CREECH AIR FORCE BASE, CLARK COUNTY, NV
DISASTER RESILIENCY PROGRAM (DRP) - PHASE 2

STRUCTURAL DESIGN CRITERIA, LEGEND, AND
ABBREVIATIONS

DP-1 95% SUBMISSION

AGE STORAGE PLAN & ELEVATION

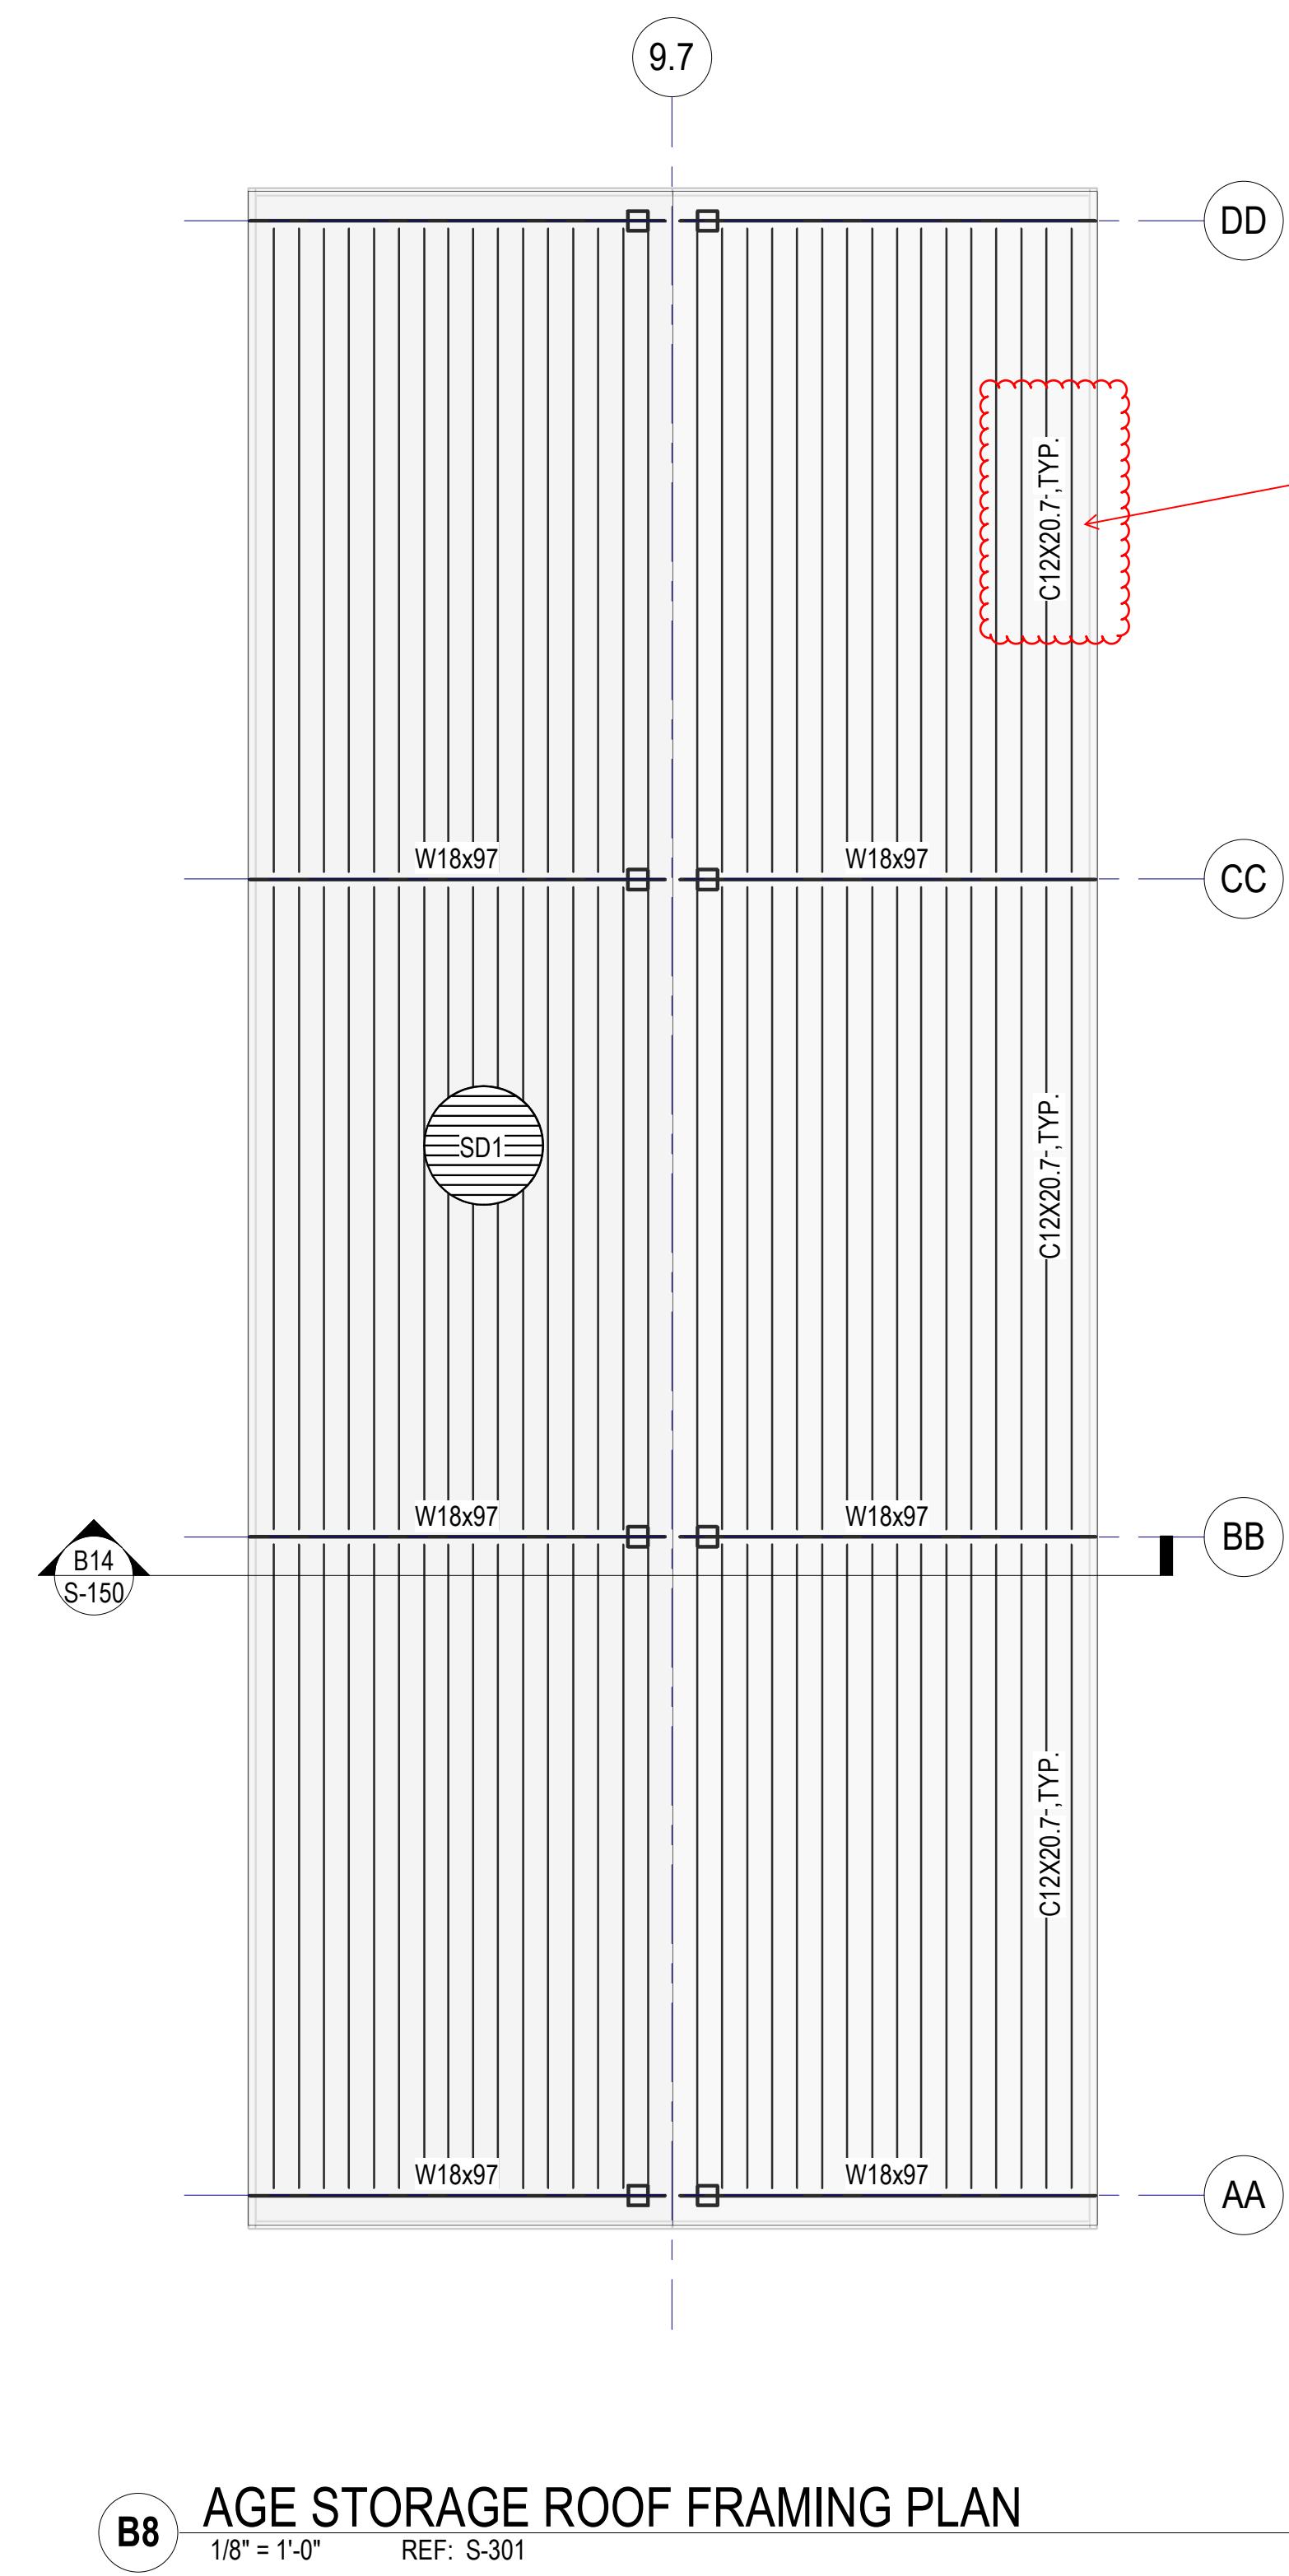
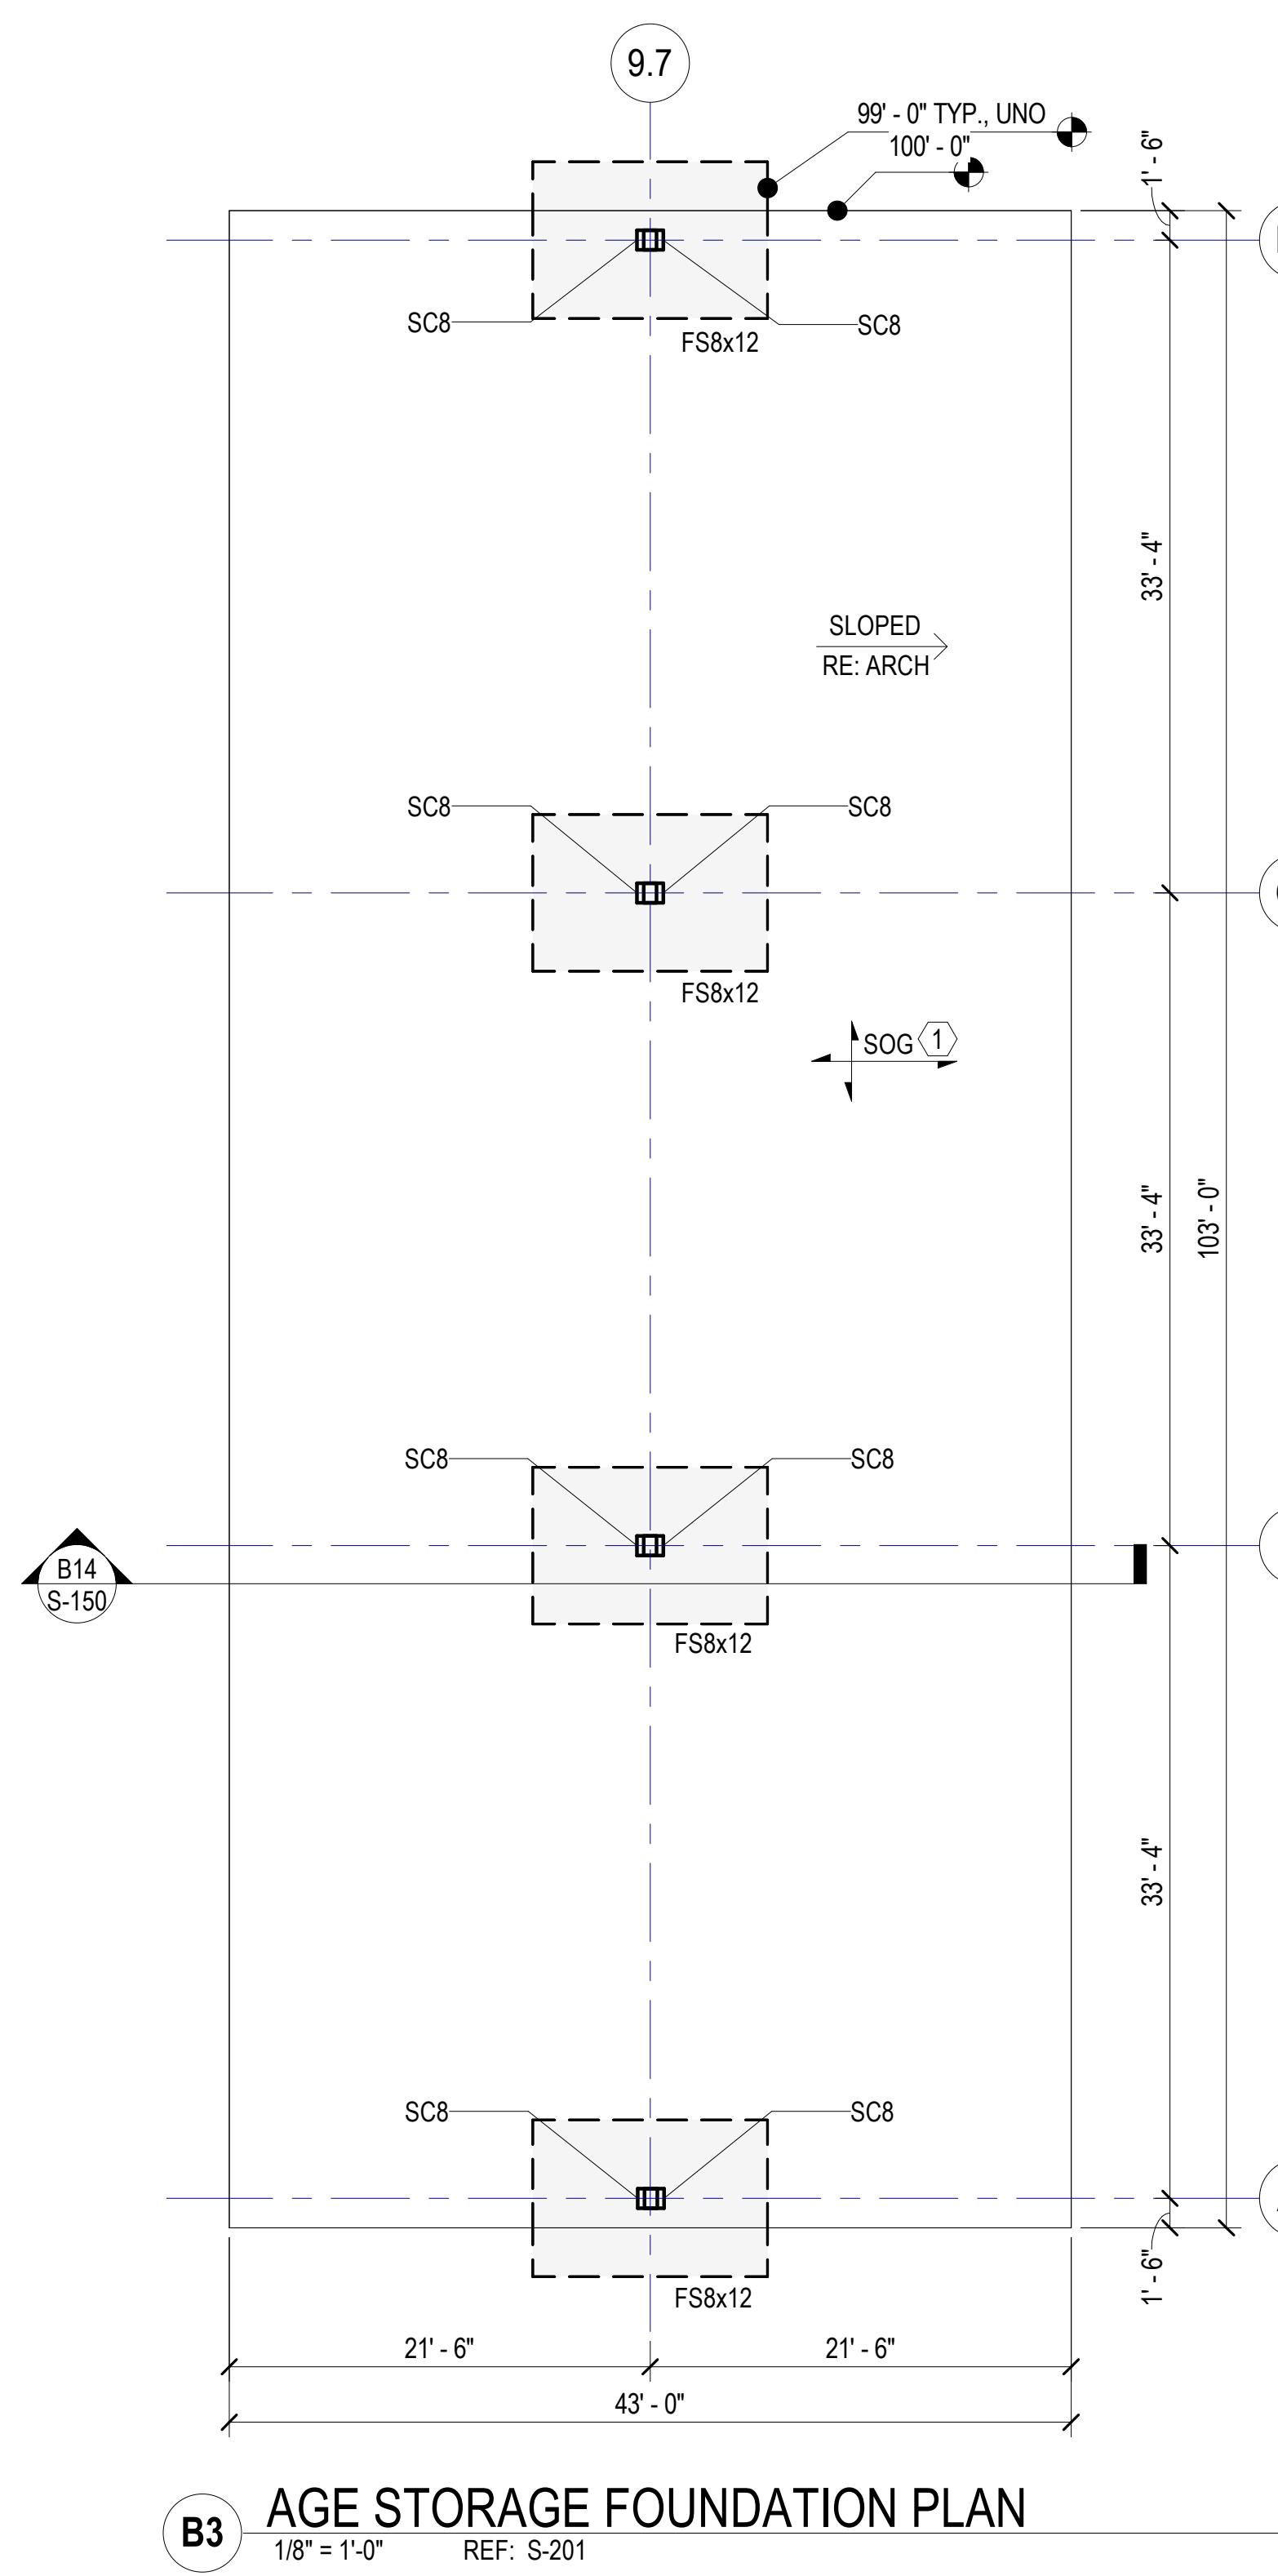
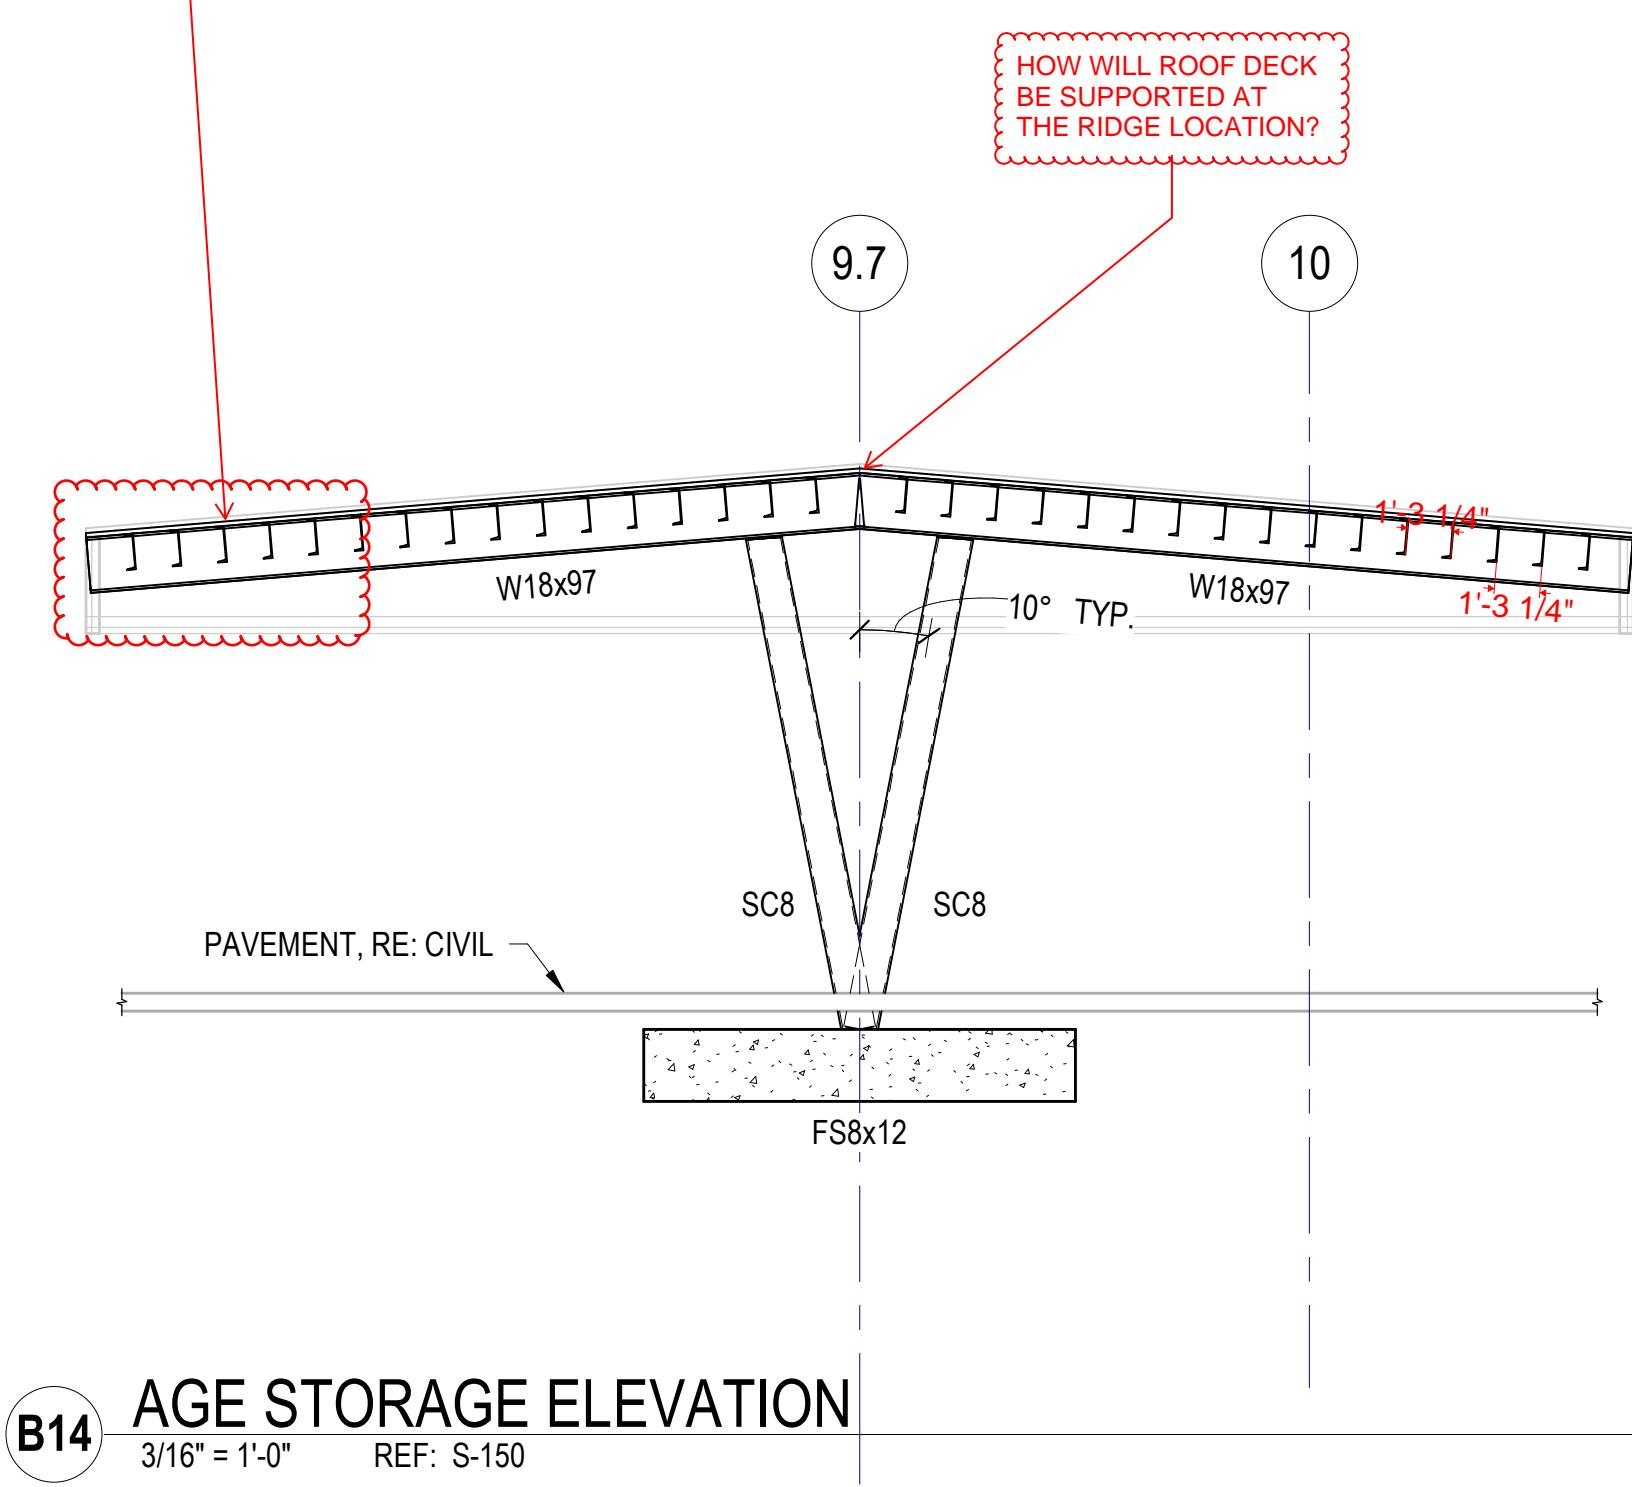
ARE THE C12X20.7
STEEL CHANNELS
SUPPOSED TO BE
SPACED AT 15" ON
CENTER AS SHOWN IN
SECTION B14? VERIFY
THAT SPACING IS
CORRECT.

STEEL GUSSET PLATE CONNECTION SCHEDULE

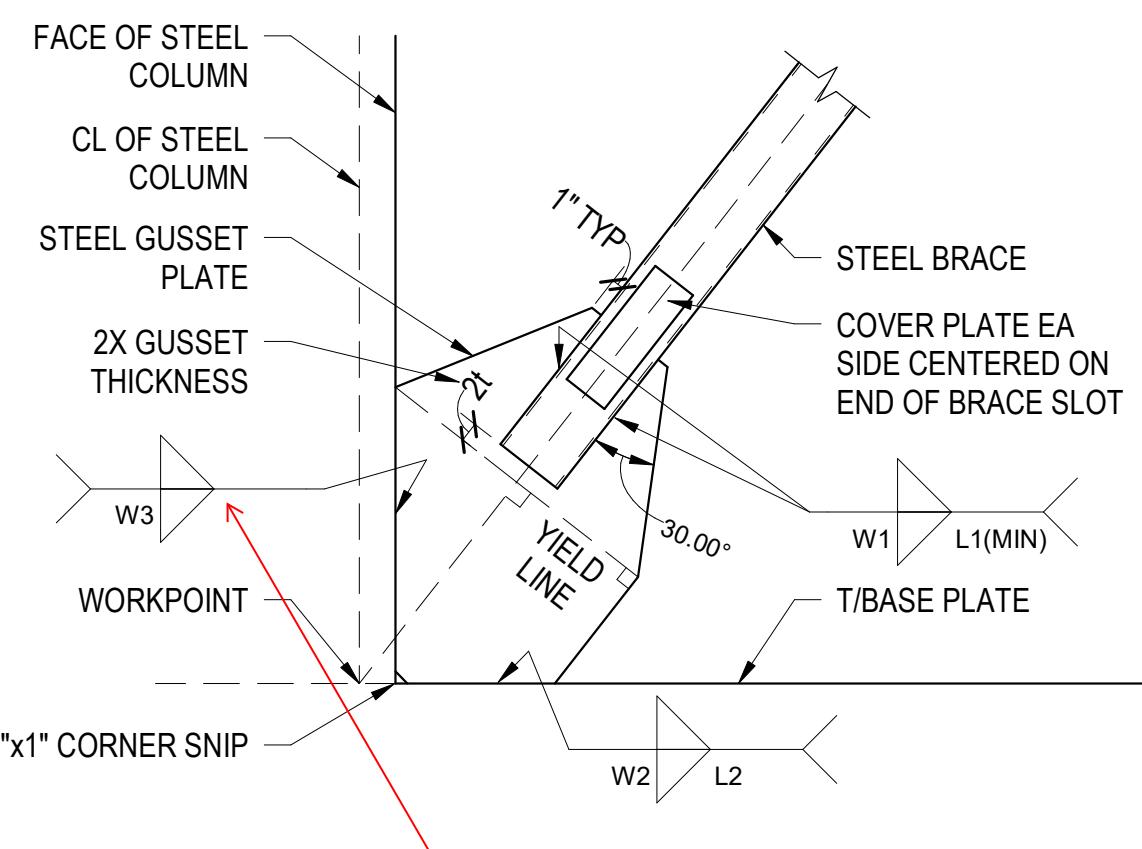
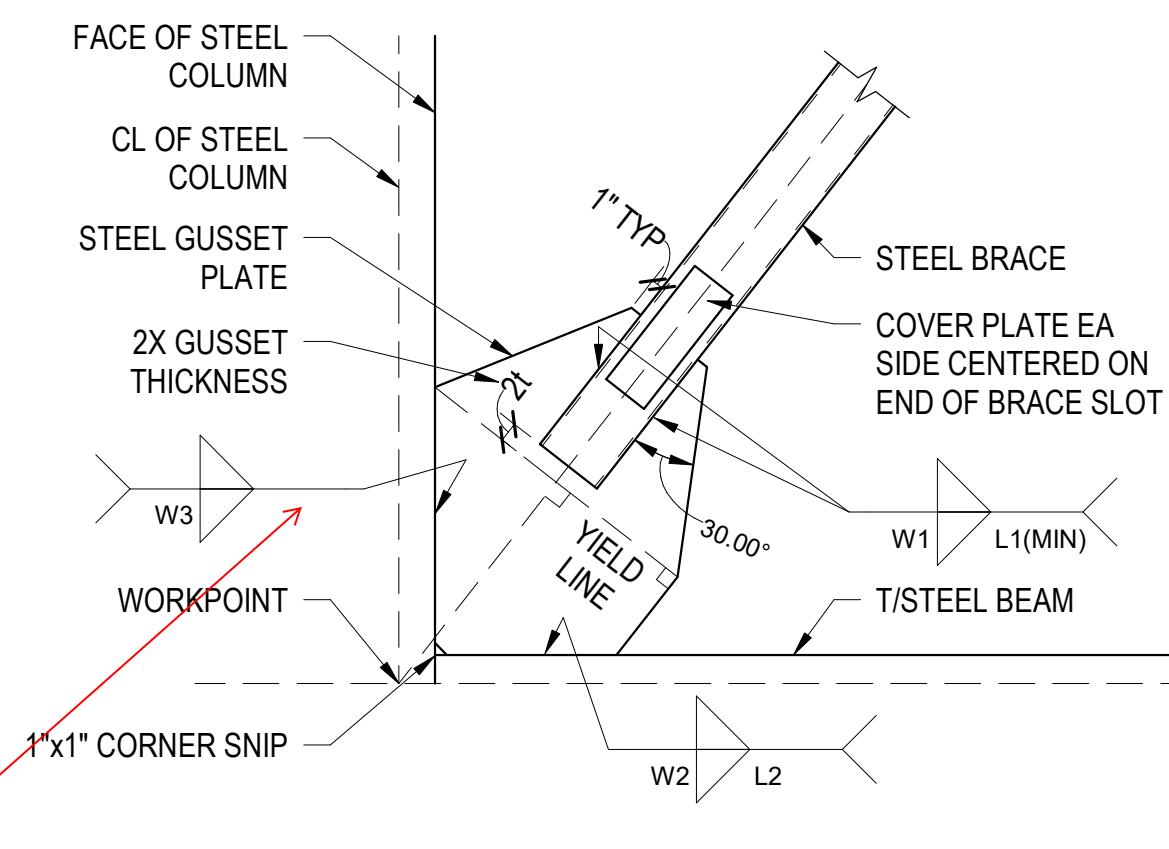
ALSO IDENTIFY THE LENGTH OF WELD ALONG THE VERTICAL GUSSET PLATE INTERFACE. ONLY IDENTIFYING THE HORIZONTAL "L2" WELD LENGTH DOESN'T FULLY DEFINE THE GUSSET PLATE GEOMETRY REQUIREMENTS TO PROPERLY ESTABLISH THE 2T YIELD (FOLD) LINE.
